SUBJECT: LEONHART, ET AL., (1984): "ANALYSIS AND INTERPRETATION OF A  
RECIRCULATING TRACER EXPERIMENT PERFORMED ON A BASALT FLOW  
TOP"

WMGT DOCUMENT REVIEW:

"Analysis and Interpretation of a Recirculating Tracer Experiment Performed on a Deep Basalt Flow Top," by L. Leonhart, R. Jackson, D. Graham, L. Gelhar, G. Thompson, B. Kanehiro, and C. Wilson, 1984

Review by Matthew Gordon, Hydrology Section, WMGT

FIGURE 1. CONTOURS OF EQUAL HEAD BUILDUP, IN METERS, FOR HOMOGENEOUS AQUIFER AS DESCRIBED IN TEXT. PUMPING RATE 1 GAL/MIN. NEGATIVE BUILDUP IMPLIES DRAWDOWN. (DC-8 ON LEFT, DC-7 ON RIGHT). THEORETICAL RESULT, FROM NUMERICAL MODEL.

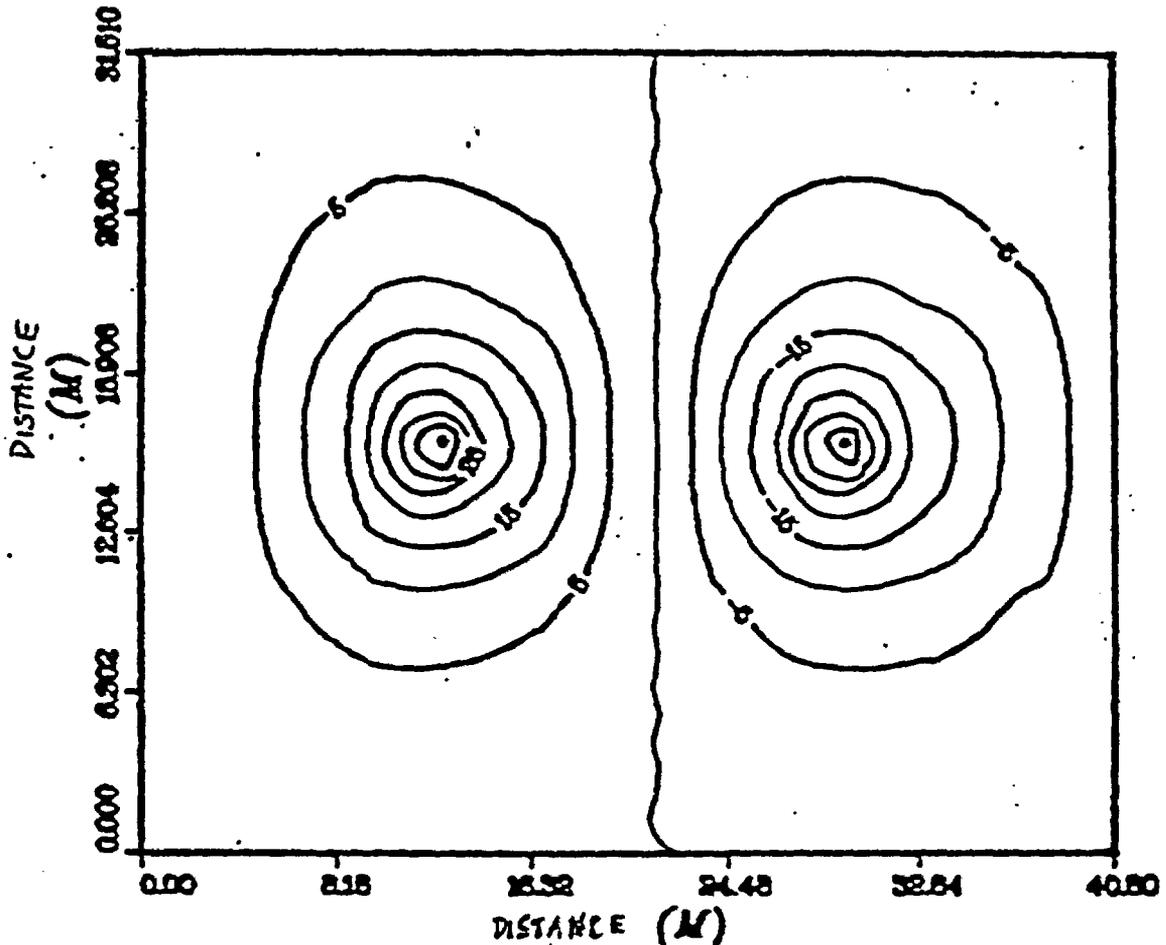
One puzzling aspect of the documented tests is the the observed development of a head buildup at DC-8 of only two feet (0.61 m) during the test, while the drawdown at DC-7 reached a magnitude of 77 feet (23.5 m). Leonhart et al. note that, "theoretically, a mirror-image symmetry should develop between the cones of impression and depression at the recharge and discharge wells under conditions of ideal homogeneity and isotropy within the flow top, and equivalent well efficiencies [apparently meaning wellbore damage or improvement (c.f. Earlougher, 1977) in this context] and under conditions of equal flow" (p. 28). Leonhart et al. reason that lateral heterogeneities in the vicinity of the two boreholes, e.g., a local pinch-out of a more highly transmissive horizon within the flow top may be responsible for the observed asymmetry.

Assuming constant flow rates and an ideal homogeneous isotropic aquifer, the head impression and depression within the aquifer, but not necessarily within the well, would be expected to be symmetrical. The expected head distribution in the aquifer is illustrated in Figure 1, using the aquifer properties of Leonhart et al. (the figure and calculation is based on output from a numerical model, SWIFT, and a contouring post-processor; heads very close to the well are averaged across a larger grid block). However, a difference in the magnitude of drawdown/buildup within the boreholes themselves would in fact be expected due to the differing radii of the two wells: DC-7 being 0.11 m radius, and DC-8 being 0.04 m radius. (We note that inches have been inaccurately converted to centimeters on page 6 of the document.) The inequality in the observed borehole drawdown/buildup is, however, opposite to what would be expected theoretically, i.e., DC-8 (the smaller hole) had less buildup than DC-7 had drawdown. Assuming the value of aquifer transmissivity as noted in Leonhart et al., the expected drawdown in DC-7 would be about 67.3 meters at steady state, while the buildup in DC-8 would theoretically be about 81.5 meters (based on a calculation using equation 8-155 from Bear (1979)) for the 1 gal/min pumping/injection rates). Both of the observed drawdown/buildup magnitudes are less than would be expected theoretically; and the 0.61 m observed buildup at DC-8 is particularly inconsistent with the expected value. This could possibly be due to the aquifer having a higher transmissivity than assumed, with a local low transmissivity zone or wellbore skin near DC-7. Alternatively, a very conductive fracture or other heterogeneity may intercept DC-8 and not DC-7; however, this would seem inconsistent with the reasonably high recovery of tracer (60%) at DC-7. Similarly, a local pinch-out of a more transmissive horizon may also explain the observed drawdown/buildup, as reasoned by Leonhart et al. The presence of a wellbore skin at DC-7 is discounted by Leonhart et al., although no clear justification for doing so is presented in the document. During an attempted pump test at DC-7 prior to the tracer test, "excessive drawdown" (p. 7) was developed at DC-7; this may be consistent with what was

observed during the tracer test, and suggests that a skin effect or the presence of lateral heterogeneities are affecting the ground-water flow near DC-7. Another explanation could be that the flow top has a higher transmissivity than assumed, with a less permeable boundary or borehole skin effect near DC-7, causing a higher drawdown at DC-7 than the impression at DC-8. At any rate, given the irregularities in the observed drawdown and buildup, it is surprising that such an excellent fit to the type curve was obtained (Figure 8 of the report).
